AGENDA
ST. TAMMANY PARISH PLANNING COMMISSION MEETING
6:00 PM – MONDAY, MARCH 18, 2024
ST. TAMMANY PARISH GOVERNMENT COMPLEX
PARISH COUNCIL CHAMBERS
21490 KOOP DRIVE, MANDEVILLE, LOUISIANA

PLANNING STAFF REPORT
2024-3718-MSP

REV24-03-001

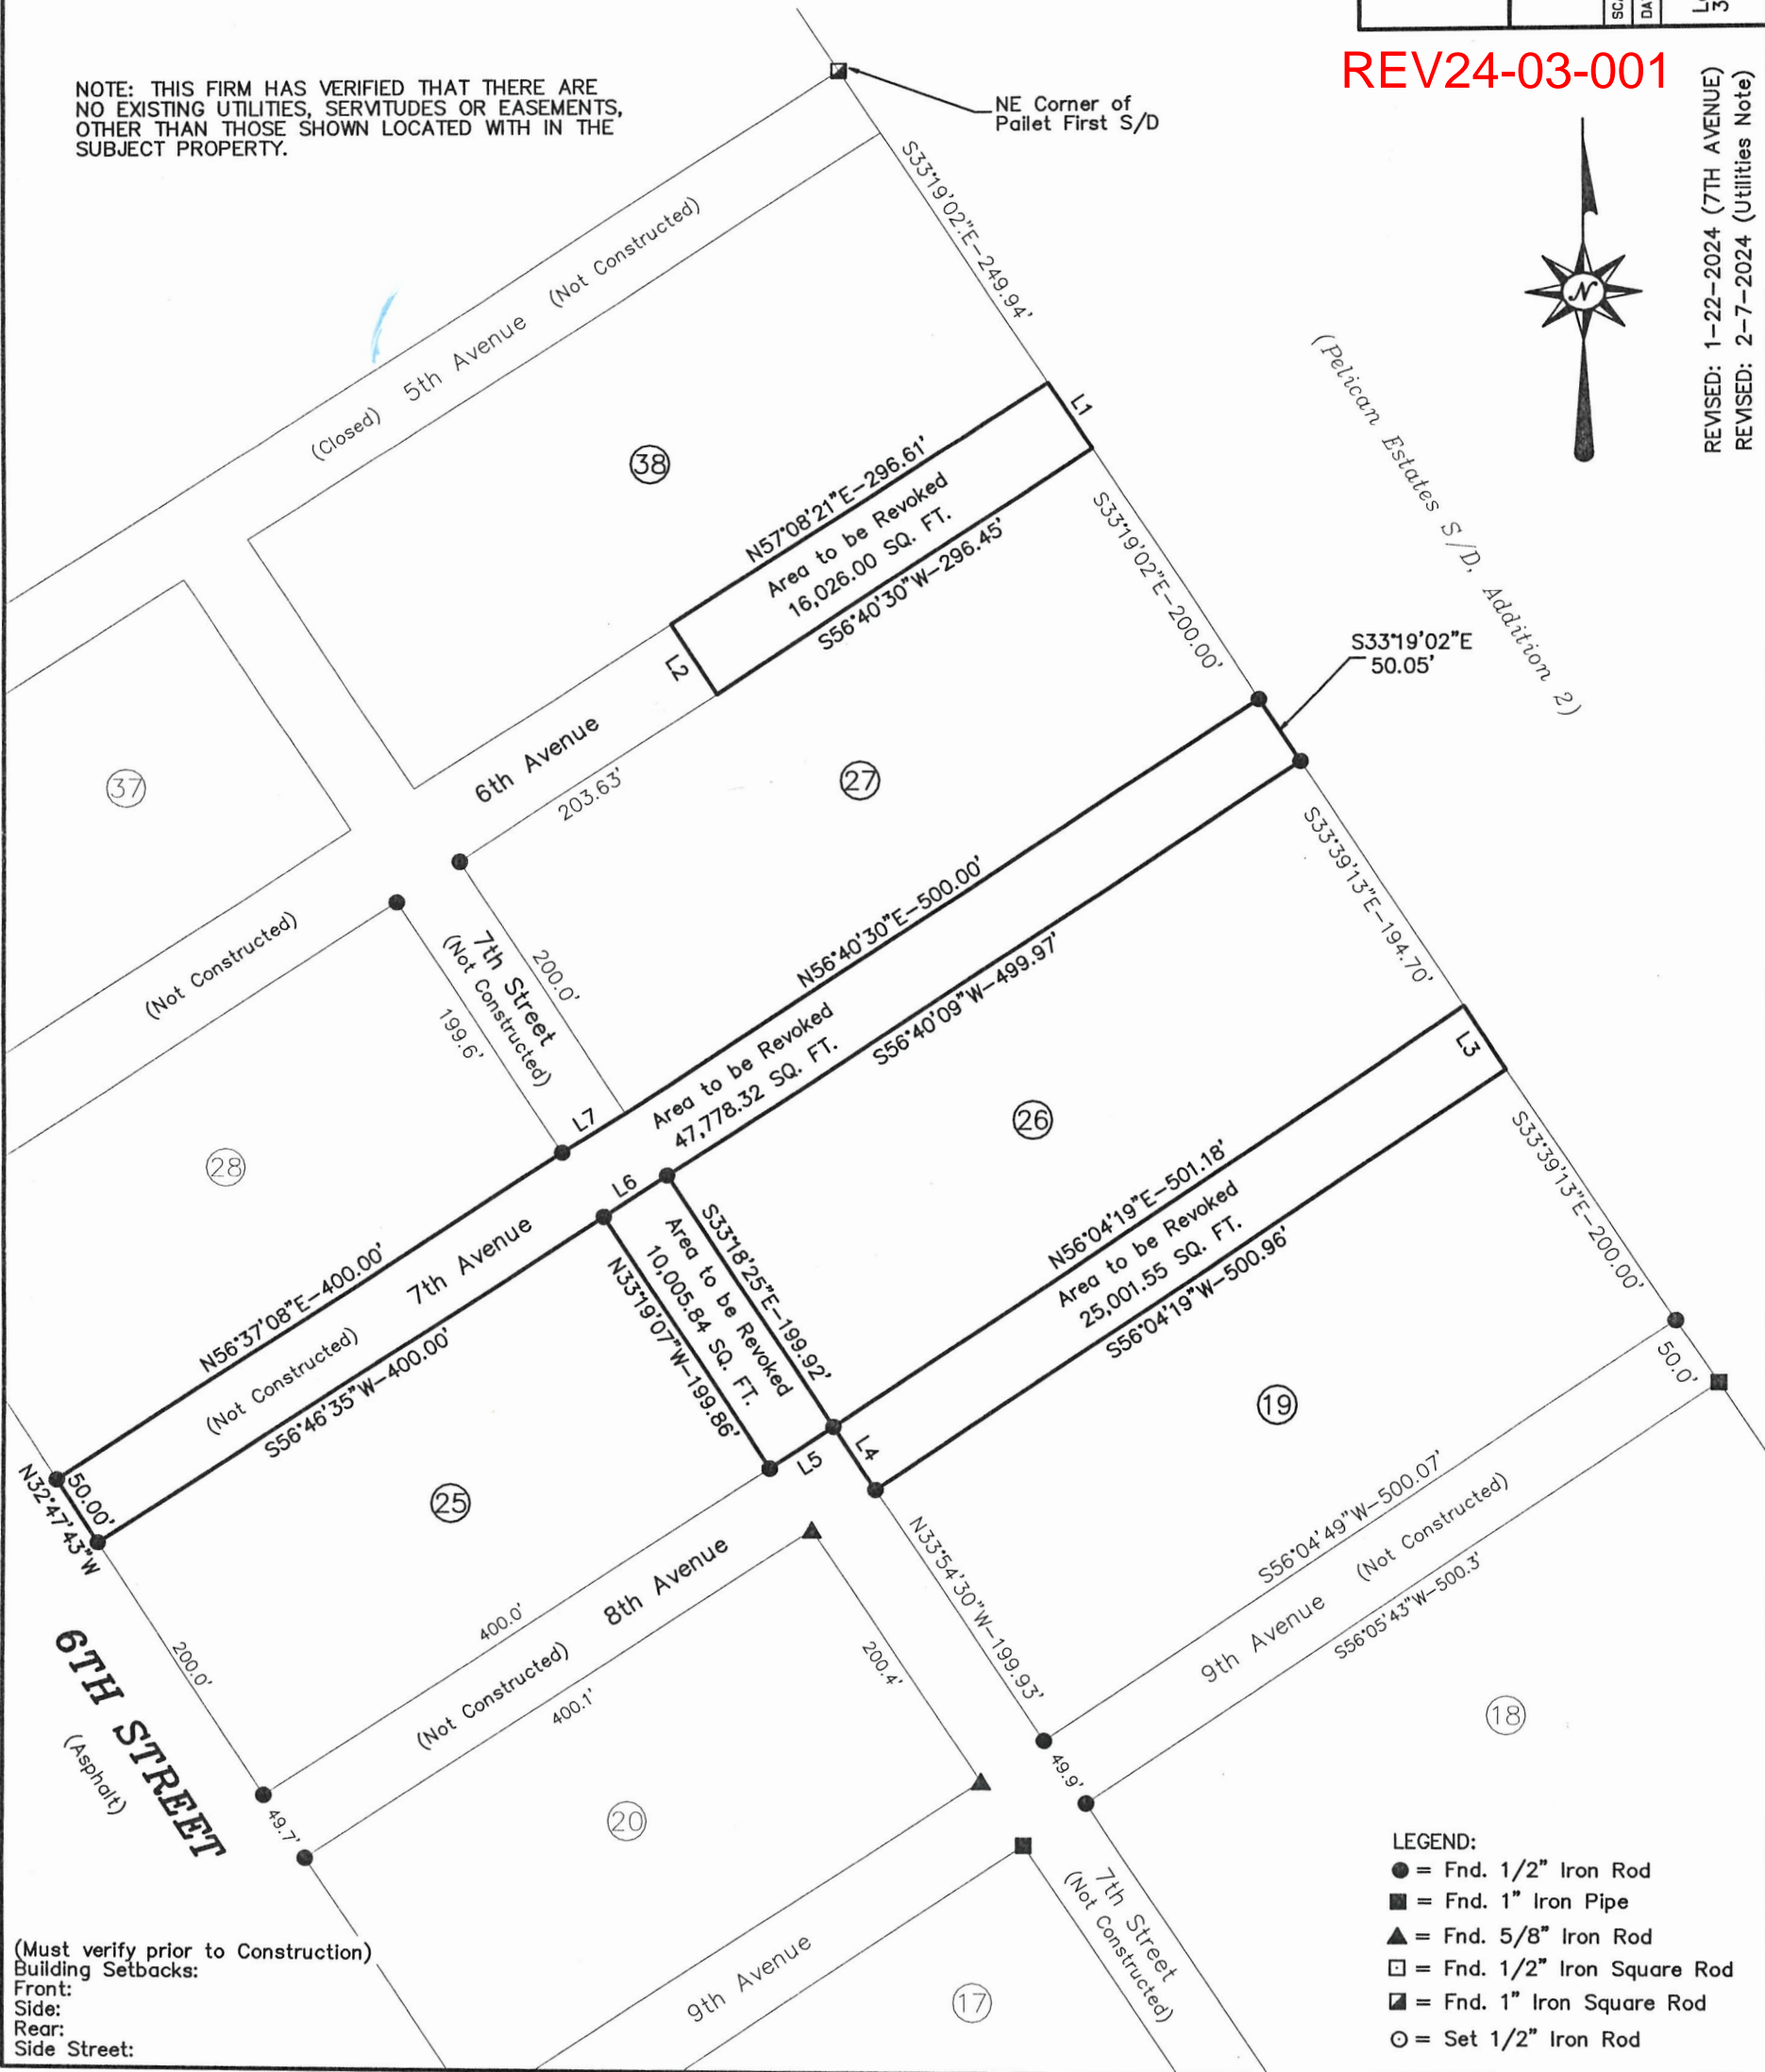
The petitioners are requesting to revoke several portions of right-of-way in the Paillet First Subdivision. The petitioners plan to assimilate the unopened portions of 6th Avenue, 7th Avenue, 8th Avenue, and 7th Street right-of-ways into their adjacent properties in order to create two (2) large parcels.

Staff believes that the proposal is consistent relative to the Louisiana Revised Statutes governing the revocation of immovable property since the right-of-way does not appear to serve any public use or benefit, other than to the applicant. Therefore, staff has no objections to the requested revocation subject to the applicant assimilating the portions of the right-of-way into their adjacent properties through the parish's resubdivision process.

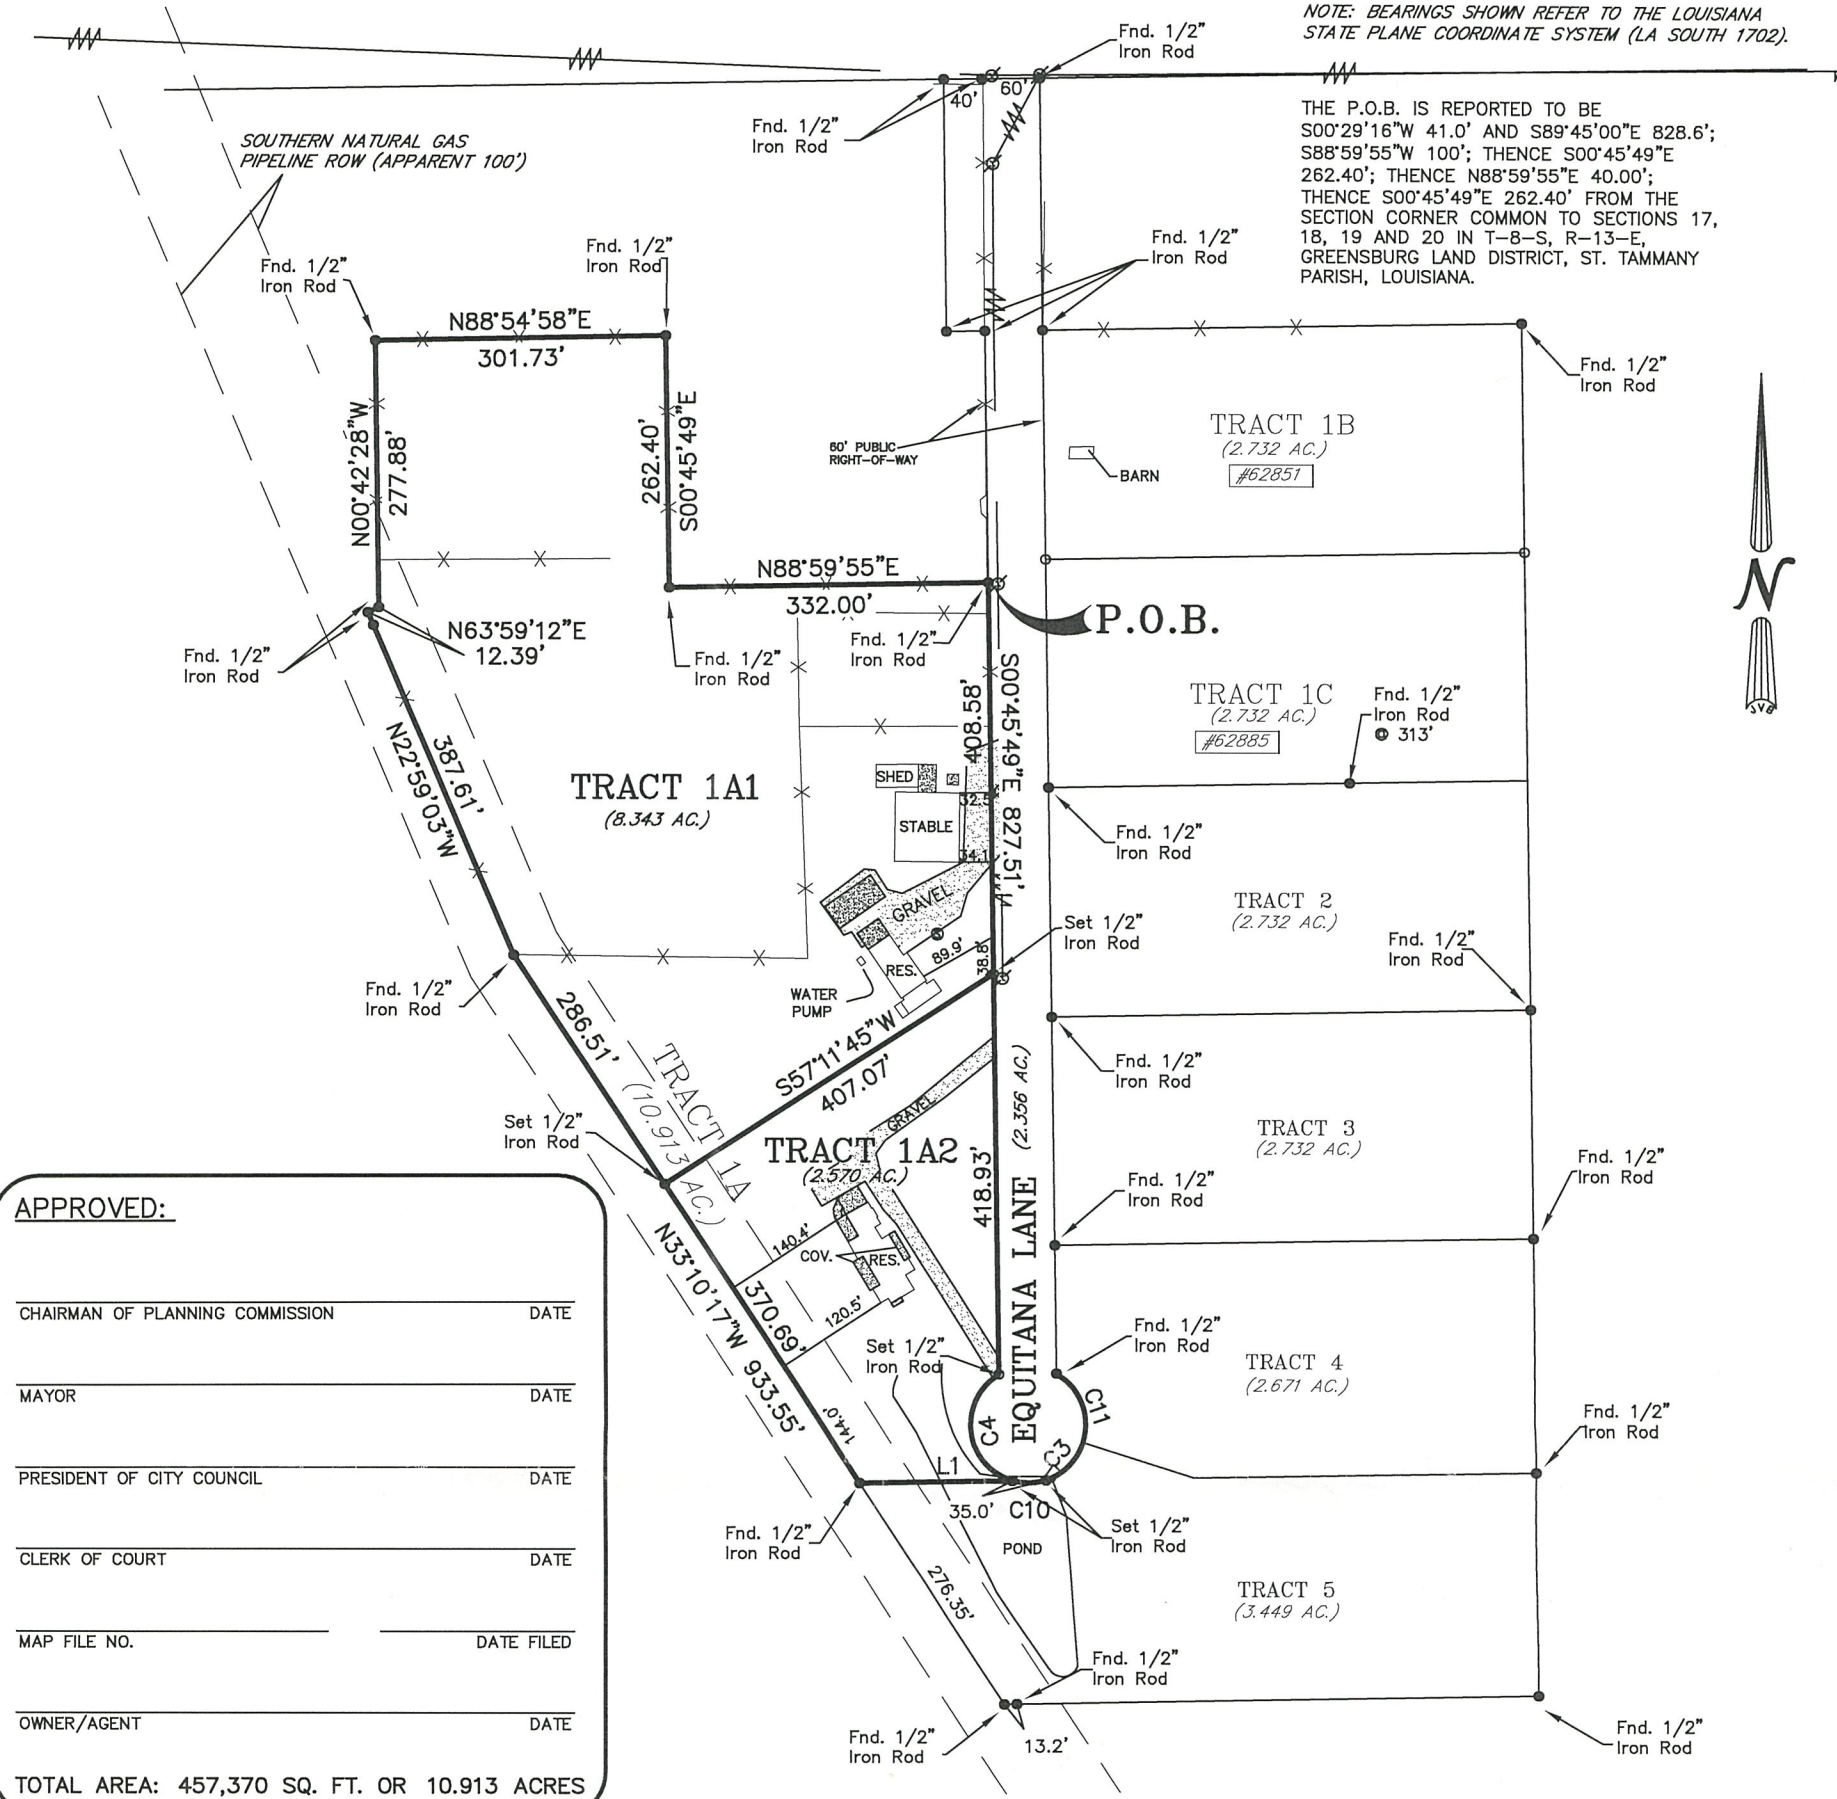
1. Remove the signature line titled "Mayor" from the survey.
2. Remove the signature line titled "President of City Council" from the survey.
3. Add a signature line for the "Secretary of the Planning Commission" to the survey.
4. Add a signature line for the "Director of Engineering" to the survey.
5. Remove the signature line for the "Owner/Agent" from the survey or have the "Owner/Agent" sign all surveys prior to recordation.
6. Confirm that the existing residence located on proposed Tract 1A1 will meet the minimum side yard setback of 15 feet required under the A-2 Suburban Zoning District.

2024-3719-MRP

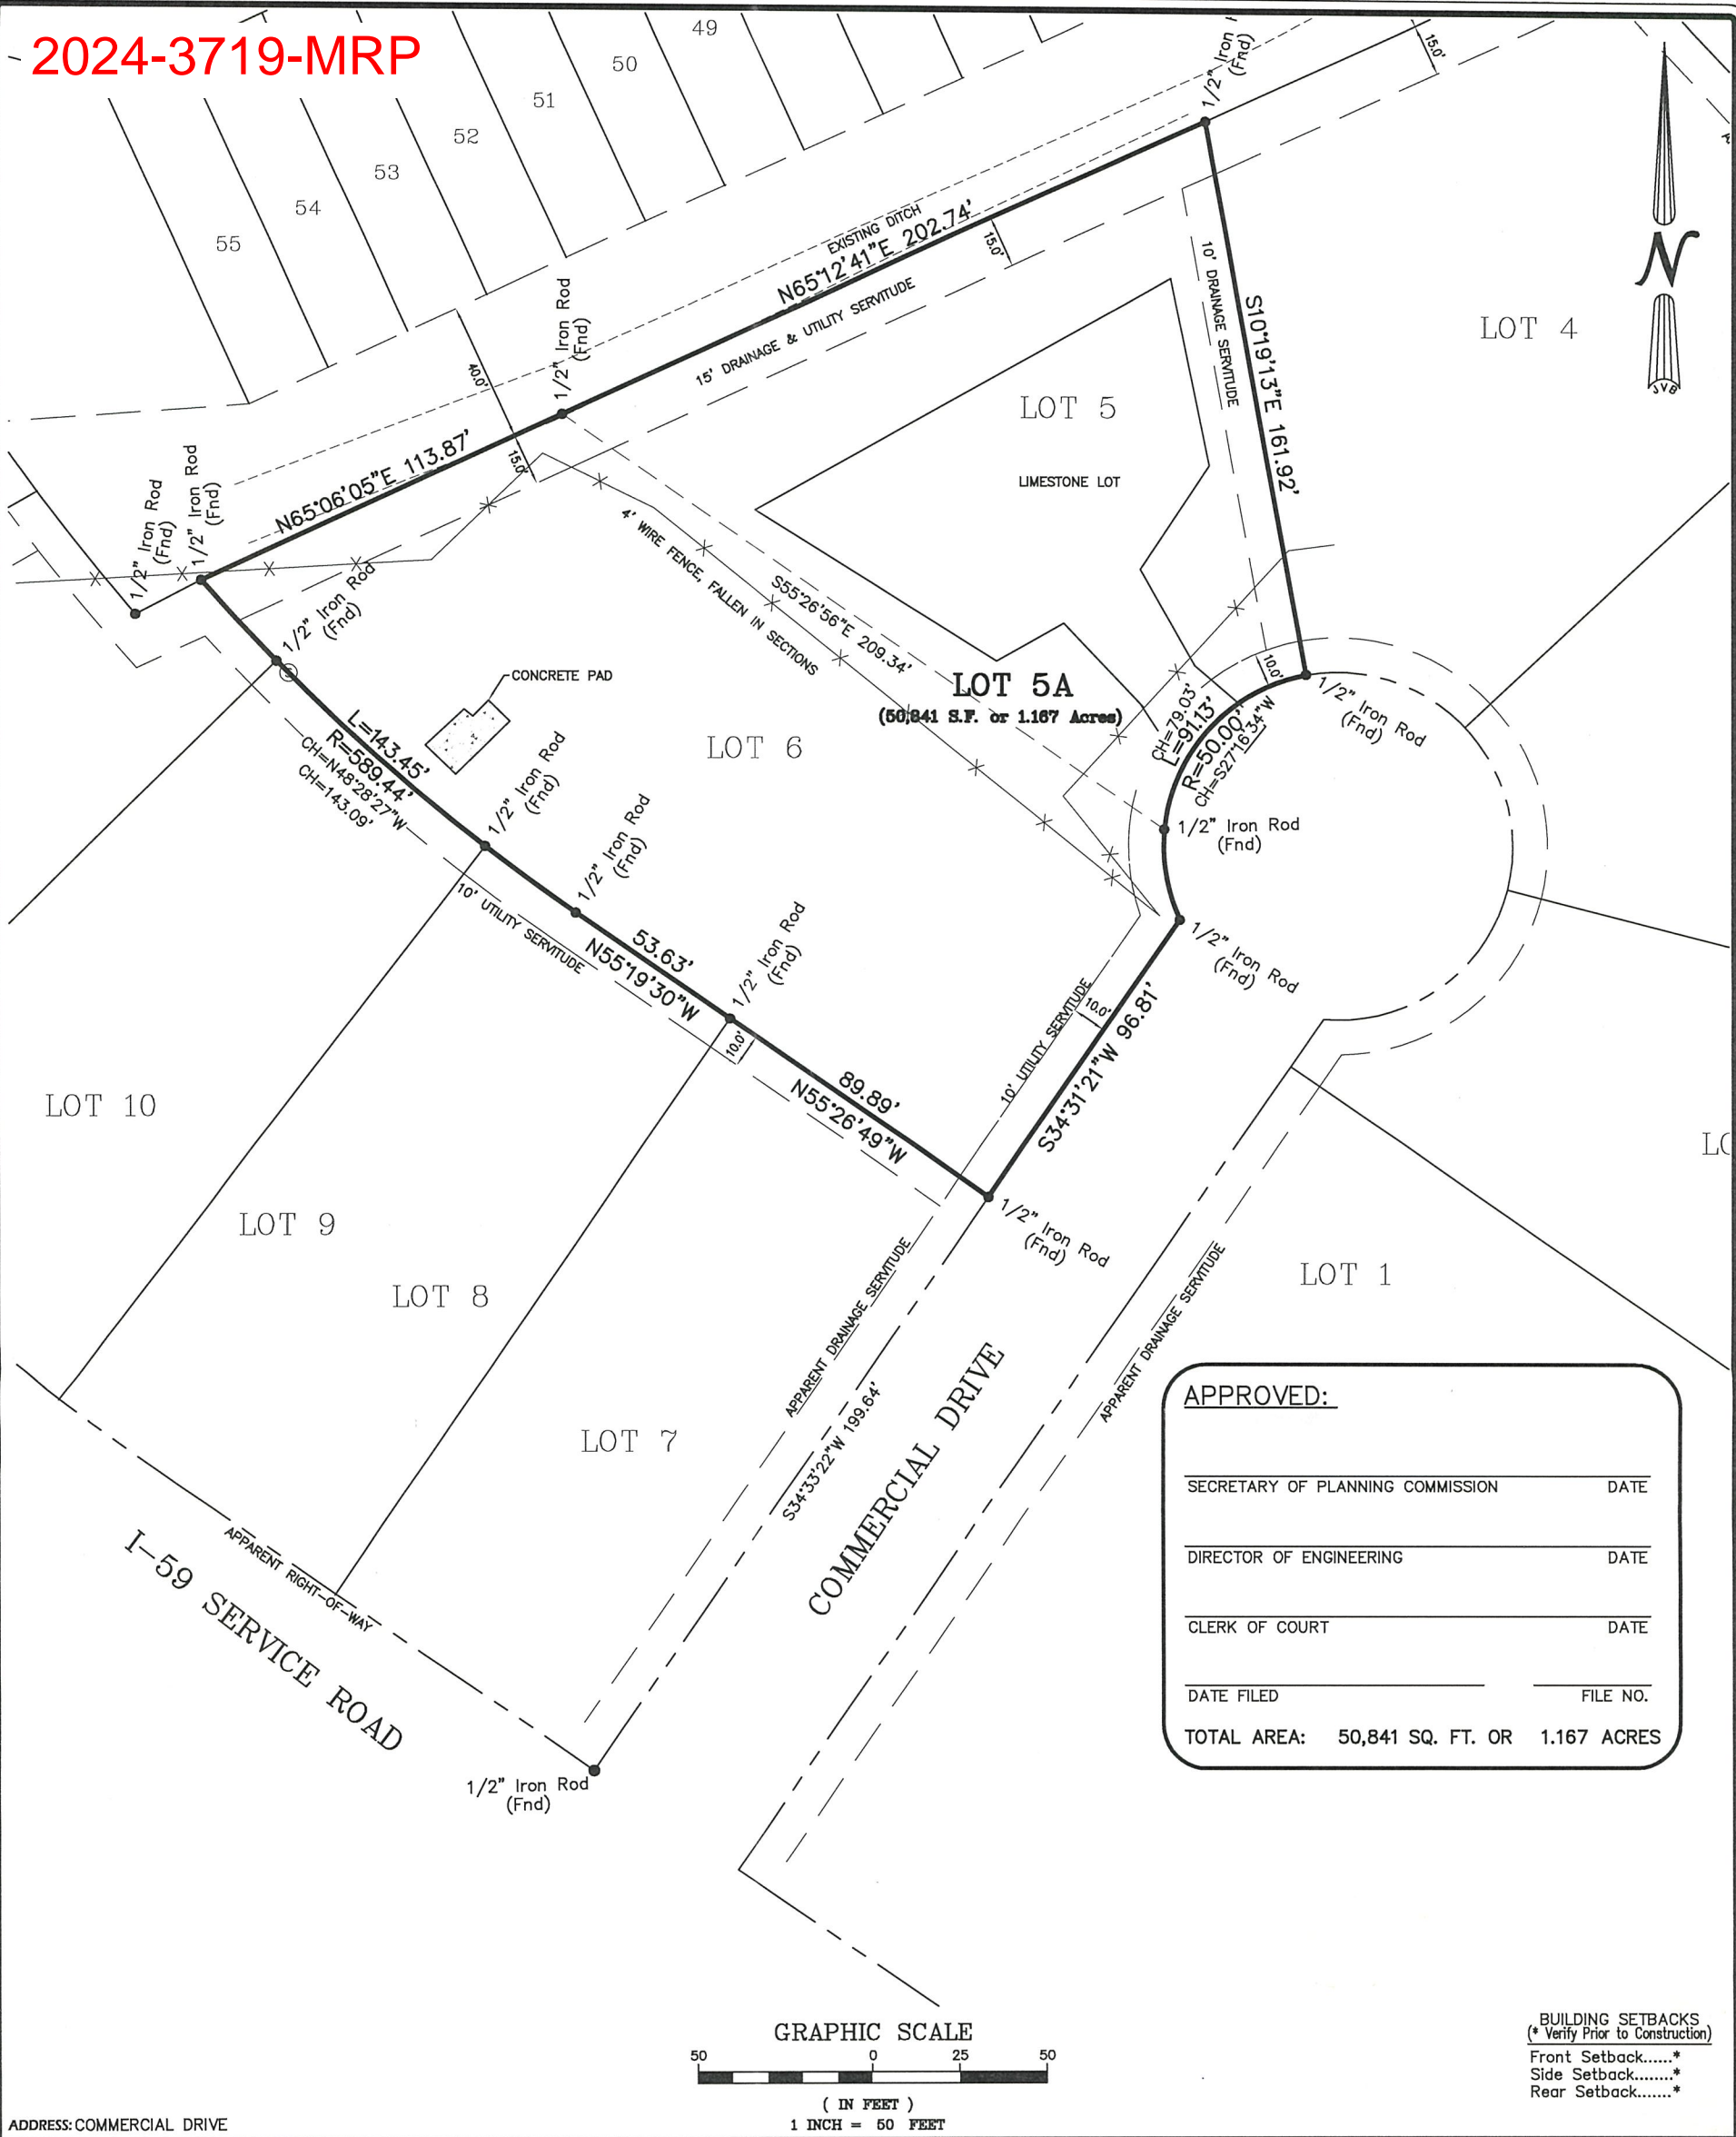
1. Add signature line for the Chairman of the Planning Commission.
2. Add a Map File to reference the I-59 Commercial Park Subdivision final plat approval.
